Informal document **GRSG-114-21**
(114th GRSG, 9-13 April 2018
agenda item 5.)

Proposal for a new UN Regulation on uniform provisions concerning the approval of motor vehicles with regard to the Blind Spot Information System

The text reproduced below was prepared by the secretary of the IWG on Awareness of Vulnerable Road Users proximity in low speed manoeuvres (VRU-Proxi) to demonstrate the current status of the proposed regulation on Blind Spot Information Systems.

Figure 1: Dynamic Tests

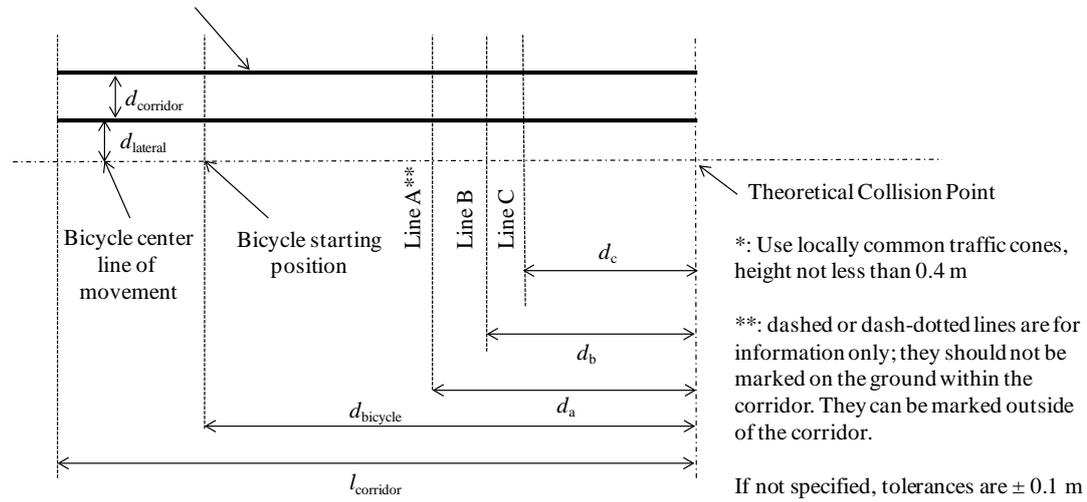
Comment [w6]: To be discussed bas on general GSR approach. Options see comment to 5.3.1.3. (require speeds). Proposal: P/F criteria is LPI at 15 m line all cases.

Figure 2: Static Tests

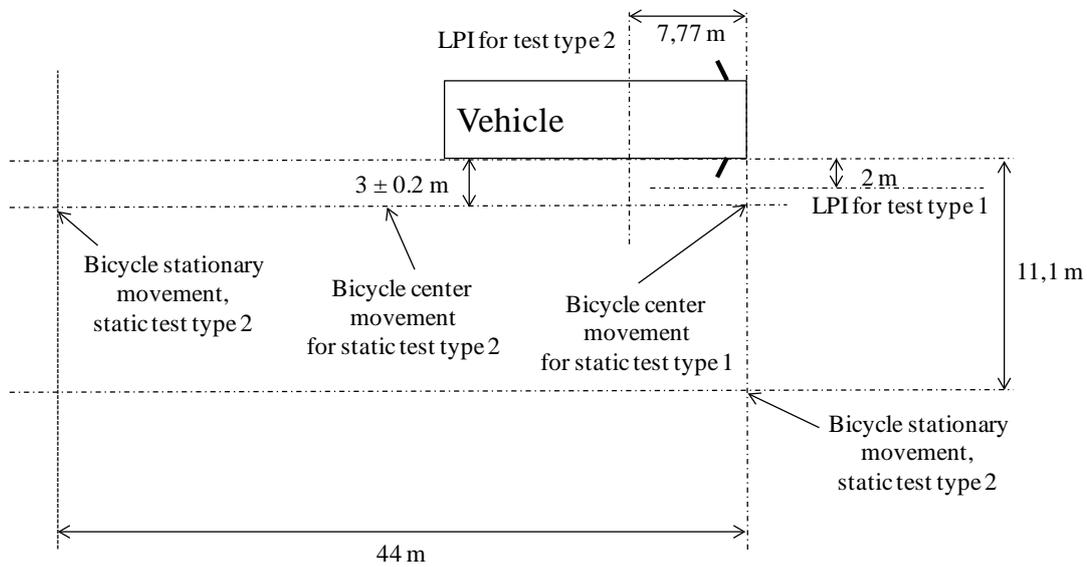
Comment [s8]: Background: This test meant to replicate roundabout situations

Comment [s9]: equals approx. 1.4 s TTC

Comment [s10]: No further definitio of planes is needed to my understanding m away refers to the position the bicycle would impact the vehicle on its line of movement.

Comment [s11]: Background: This test is meant to replicate situations with a stopped truck due to traffic and fast approaching (additional) bicycles from t rear.

Comment [s12]: equals approx. 8 s TTC

Comment [s13]: equals approx. 1.4s TTC for 20 km/h
